SUNDRY NOTICES AND REPORTS ON WELLS
Do not use this form for proposals to drill or to re-enter an abandoned well. Use form 3160-3 (APD) for such proposals.

8. Well Name and No.
DELLA 29 FED COM 603H

EOG Resources requests an amendment to our approved APD for this well to reflect a revised casing design as attached.

**Lea County, New Mexico
Revised Wellbore 11/5/18**

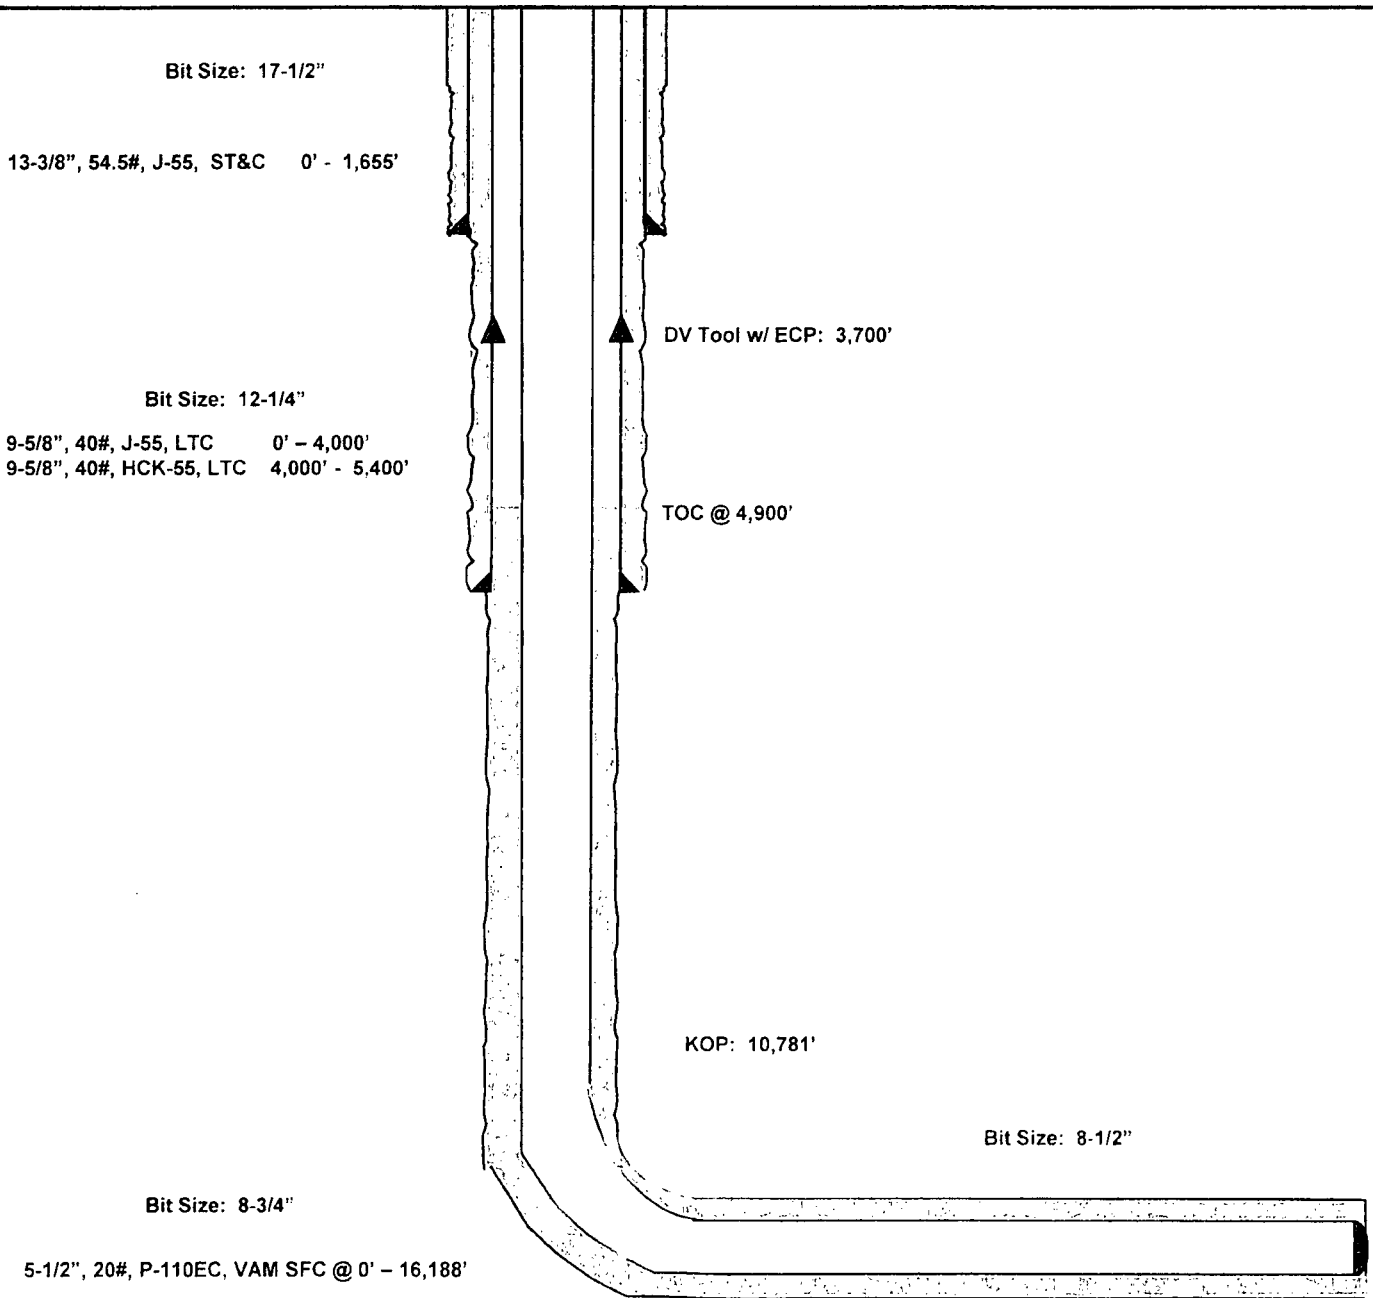
Revised Permit Information 11/5/18:

Hole Size	Interval	Csg OD	Weight	Grade	Conn	DF _{min} Collapse	DF _{min} Burst	DF _{min} Tension
17.5"	0 - 1,655'	13.375"	54.5#	J55	STC	1.125	1.25	1.60
12.25"	0 - 4,000'	9.625"	40#	J-55	LTC	1.125	1.25	1.60
12.25"	4,000' - 5,400'	9.625"	40#	HCK-55	LTC	1.125	1.25	1.60
8.75"	0' - 16,188'	5.5"	20#	HCP-110	SFC	1.125	1.25	1.60

Variance is requested to wave any centralizer requirements for the 5-1/2" FJ casing in the 8-3/4" hole size. An expansion additive will be utilized, in the cement slurry, for the entire length of the 8-3/4" hole interval to maximize cement bond and zonal isolation.

1. The 13-3/8 inch surface casing shall be set at approximately **1655** feet (a minimum of 25 feet into the Rustler Anhydrite and above the salt) and cemented to the surface.

2. The minimum required fill of cement behind the 9-5/8 inch intermediate casing is: Wait on cement (WOC) time for a primary cement job is to include the lead cement slurry due to cave/karst or potash.

3. The minimum required fill of cement behind the 5-1/2 inch production casing is: Cement to surface. If cement does not circulate, contact the appropriate BLM office. **Additional cement maybe required. Excess calculates to -58%.**
